**Re: Response to MassDEP Comments
Notice of Intent Application
DEP File #: 159-1287
160 Maple Street (Assessor’s Parcels 239-010, 254-9, and 255-1)
Franklin, Massachusetts**

On behalf of the Applicant, Maple Street Solar, LLC, LEC Environmental Consultants, Inc., (LEC) is submitting this response to comments provided by MassDEP, dated March 6, 2024. The following are MassDEP’s comments in **bold**, followed by a response from LEC in [blue font](#).

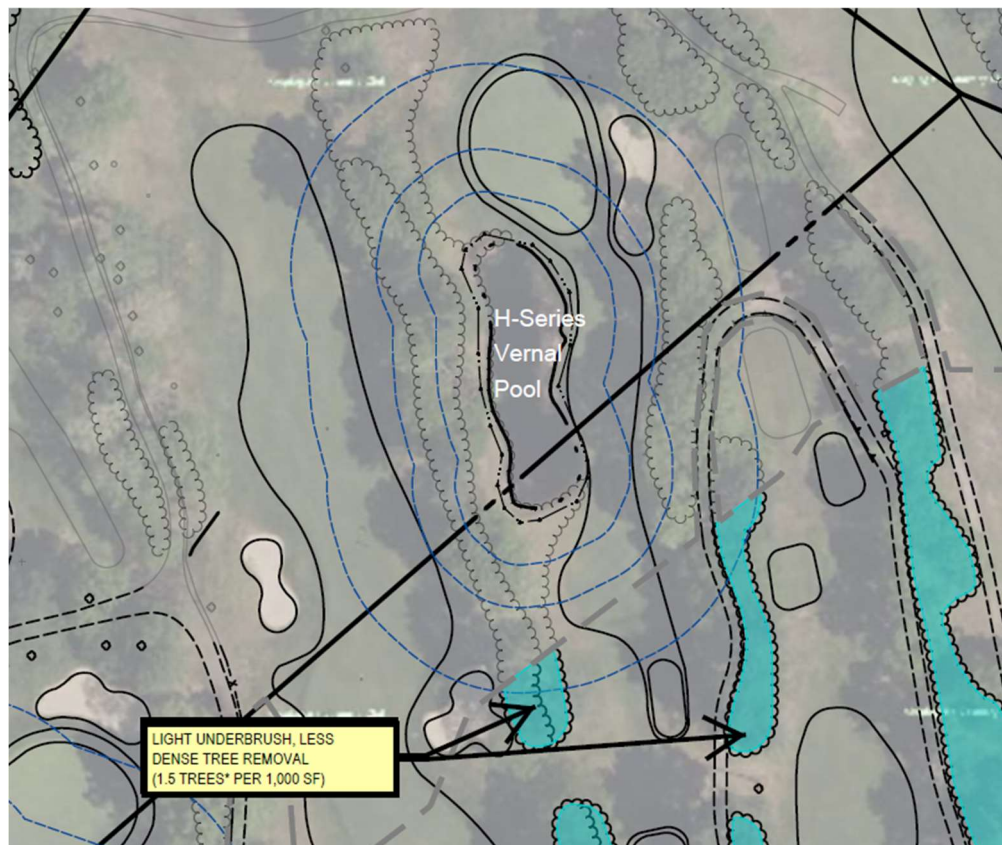
- 1. The applicant should provide a wetland replication plan that meets the Massachusetts Inland Wetland Replication Guidelines (2022), which includes but is not limited to proposed grading; area cross-section; plant quantities species, & sizes; monitoring & inspection requirements; and soil specifications.**

The most recent plans titled *Proposed Site Plan Documents for Maple Street Solar LLC* prepared by Bohler, dated 7/20/2023, last revised February 21, 2024 were submitted to the Commission by Bohler on February 22, 2024. As part of the revised plan set, Bohler added Landscaping Plans (Sheets C-701 through C-708). The Landscaping Plans, specifically Landscaping Plan E (Sheet C-706), contains details regarding species to be planted, quantity, and approximate locations. A note on the lower left of the sheet specifies details of the soil to be added. A Plant Schedule is located on the top right of the Overall Landscaping Plan (Sheet C-701).

The Wetland Replication Area will be created in an existing disturbed area (golf course fairway) by excavating to appropriate sub-grade, backfilling with organic-rich topsoil, and planting the area with native wetland indicator species and a wetland seed mix as detailed on the Landscaping Plans. The replication is 1,833 s.f. in extent, and is long and narrow in shape, extending approximately 115 feet long by 15 feet wide. Due to it extending only 15 feet from the existing wetland, a cross section detail and proposed grading would be difficult to represent at a suitable scale. It is anticipated that the final grade throughout the replication area and at its outer edges 15 feet upgradient of the existing wetland would be equal to, or only slightly above the existing

grade of the BVW. Since the activity will be supervised by a wetland scientist, the final grading is likely to be determined during construction, rather than relying on a proposed contour on the plans.

The Project Team anticipates a Special Condition in the Order of Conditions requiring that the construction of the replication area be supervised by a Wetland Scientist experienced in Wetland Replication in addition to monitoring for two growing seasons.

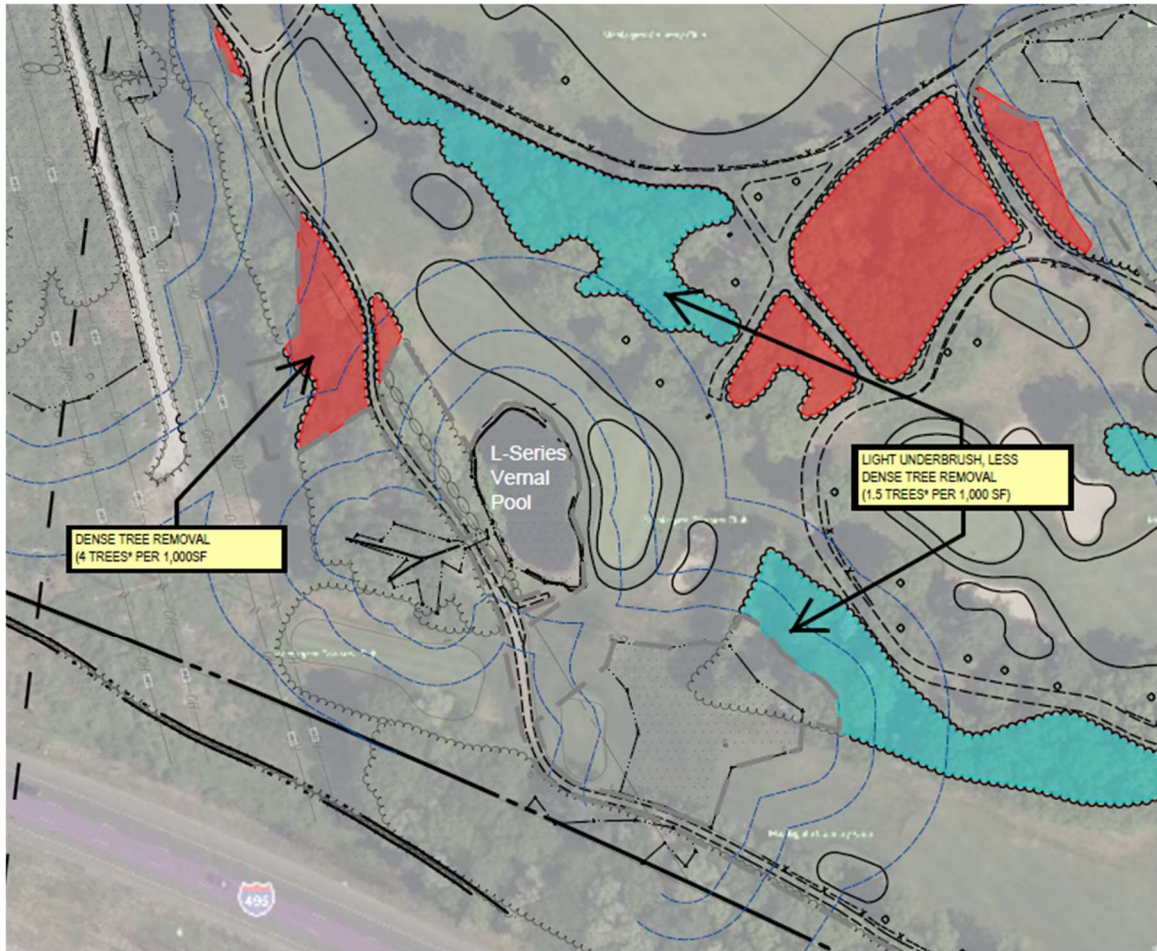
- 3. The loss of forested areas that surround vernal pools and connect the vernal pools to other wooded areas may adversely impact the future migration of amphibians to these pools.**

LEC confirmed that two wetland areas within the Project meet the criteria for certification as Vernal Pools under the NHESP Certification Guidelines, and also meet the Bylaw definition of Vernal Pool: the H-series and L-series. The H-series is located mostly north of the project boundary, within a parcel to be designated as Open Space. Limited tree clearing is proposed within 100 feet of this vernal pool, and the clearing is limited to the “light underbrush, less dense” existing forest category, as detailed on the plan titled *Tree Removal Exhibit for Maple Street Solar LLC* prepared by Bohler dated 2/21/2024, excerpted below.

This Vernal Pool will be readily accessible to migrating amphibians north of the project, via the Open Space parcel. The majority of existing forest canopy near the Vernal Pool will remain, as part of the Open Space.
